APPEAL SUMMARY

Appeal ID: 20435

Project Address: 123 SE 13th Ave

LUR or Permit Application No.: 17-145908-CO

SHEET TITLE:
Foundation/
Level 1 Slab Plan

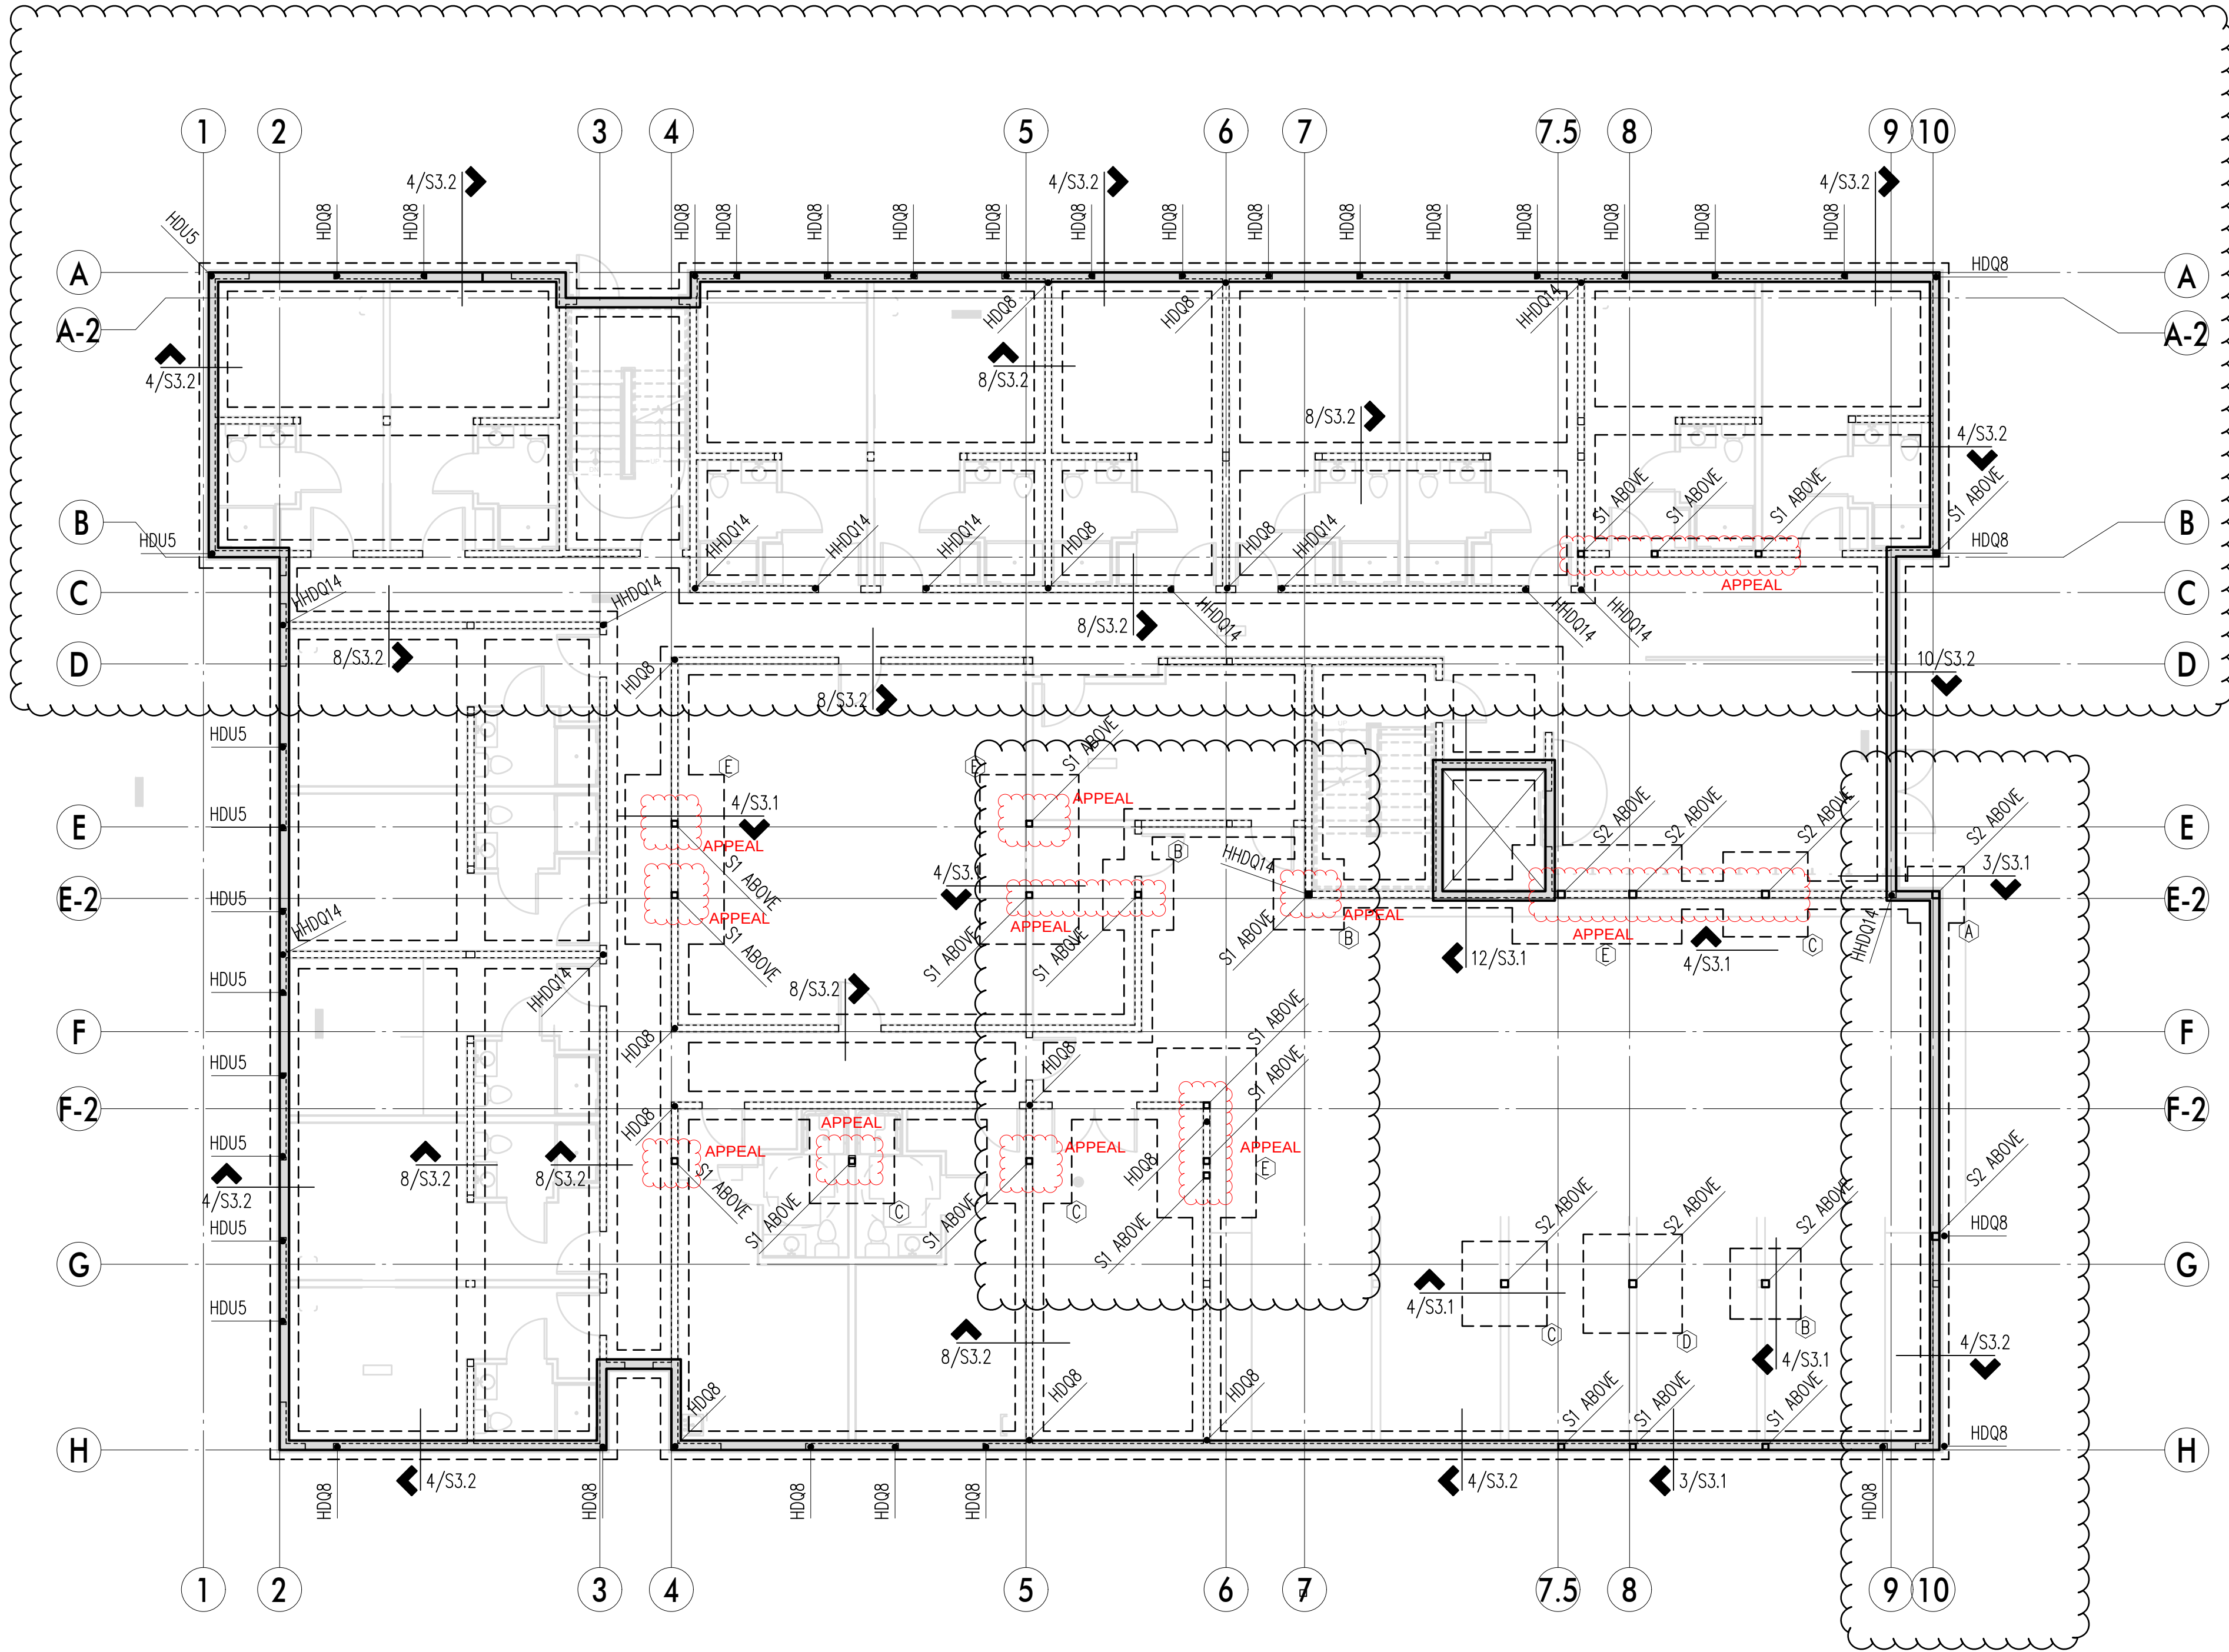
Where columns are located within fire-rated wall cavities the membrane protection of the wall provides the fire rated protection for the columns within. Therefore, columns within wall cavities are not protected (encapsulated) with fire rated construction on all four sides. Columns that occur outside of walls to be protected on all four sides with fire rated construction. The specific columns for with this appeal applies are clouded and noted on the attached framing and floor plans.

One hour fire rated protection of columns fully contained within fire rated wall membrane per 2018 IBC: Denied. Proposal does not provide equivalent Life Safety protection.
Appellant may contact John Butler (503 823-7339) with questions.

1 Steel column in 1 HR wall (Typical)
SCALE 1" = 1'-0"

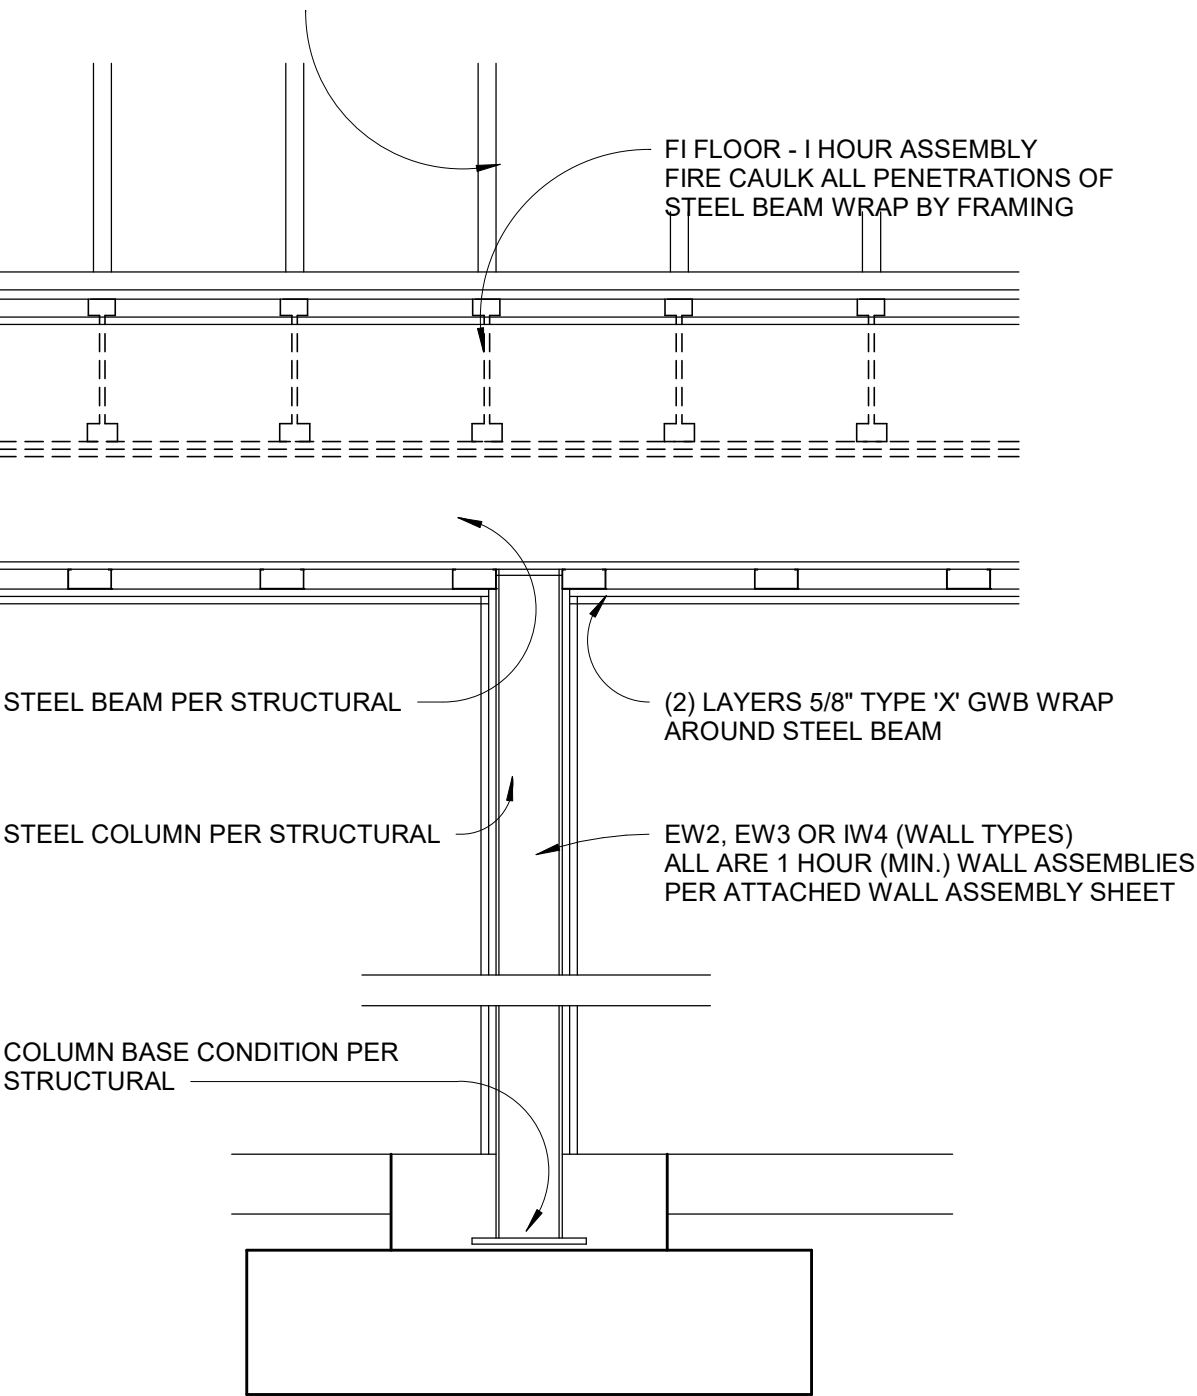
Where columns are located within fire-rated wall cavities the membrane protection of the wall provides the fire rated protection for the columns within. Therefore, columns within wall cavities are not protected (encapsulated) with fire rated construction on all four sides. Columns that occur outside of walls to be protected on all four sides with fire rated construction.

VERTICAL SECTION AT STEEL COLUMNS

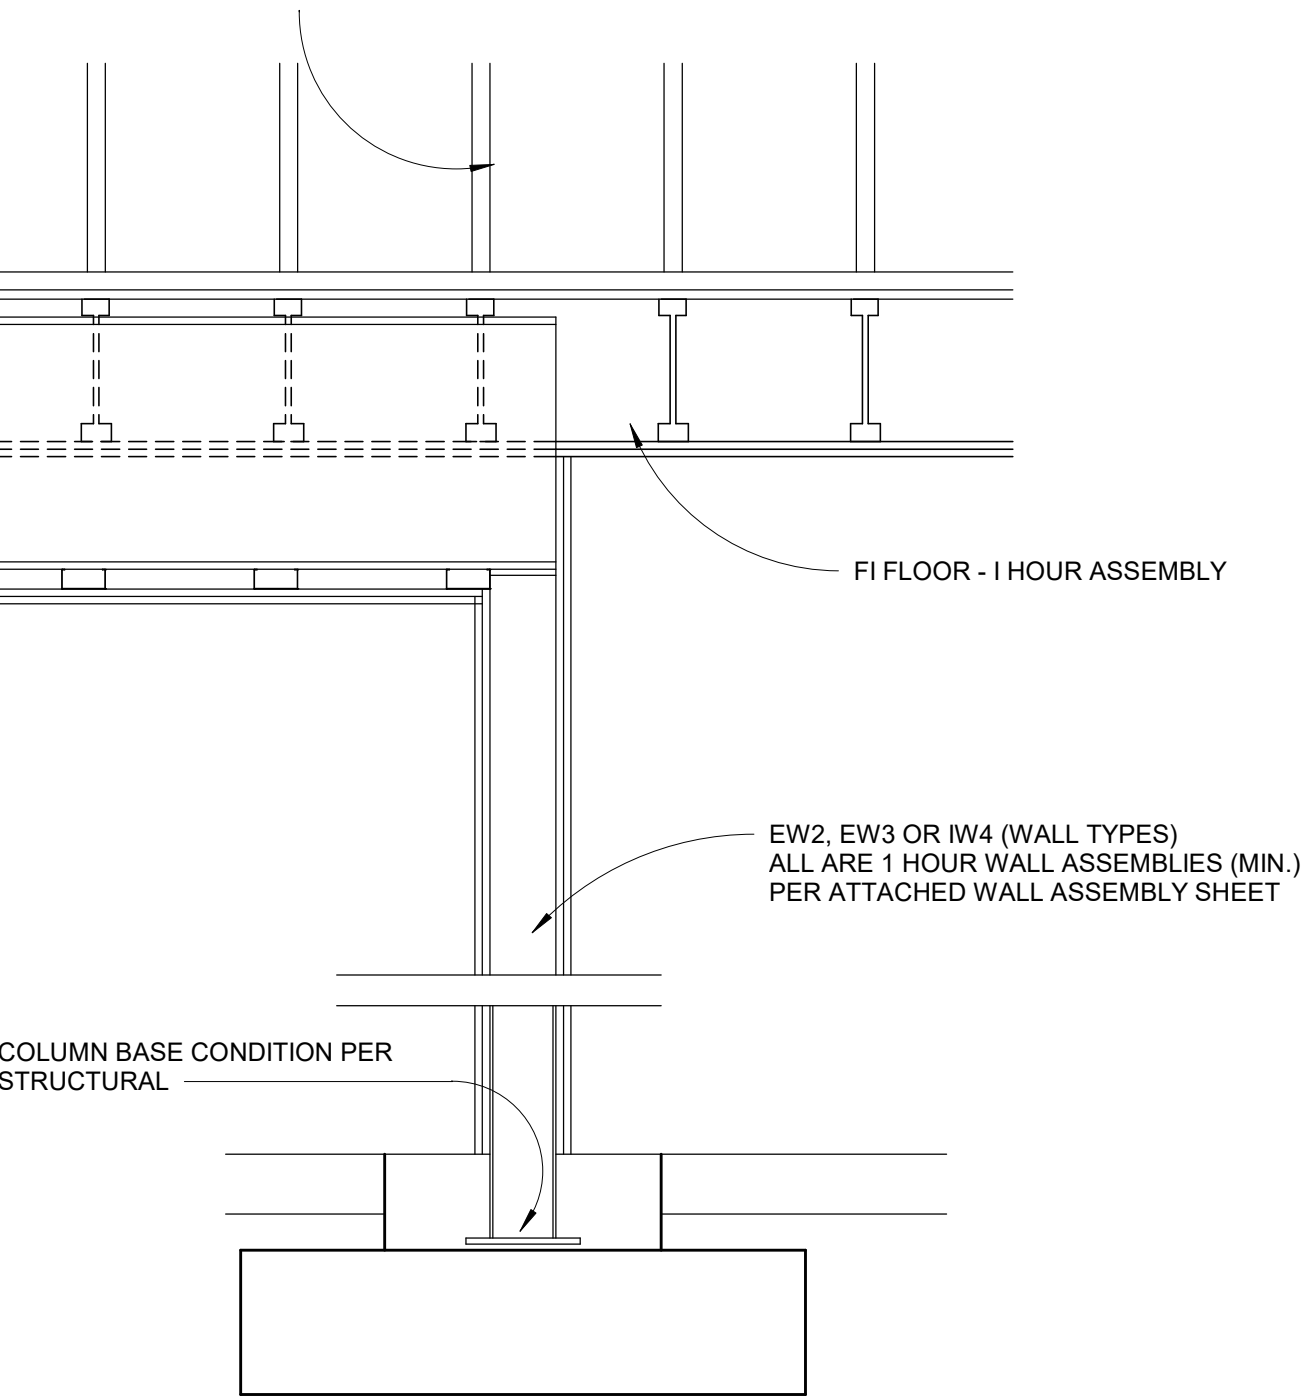
A vertical section through the steel columns has been added as requested for additional information.
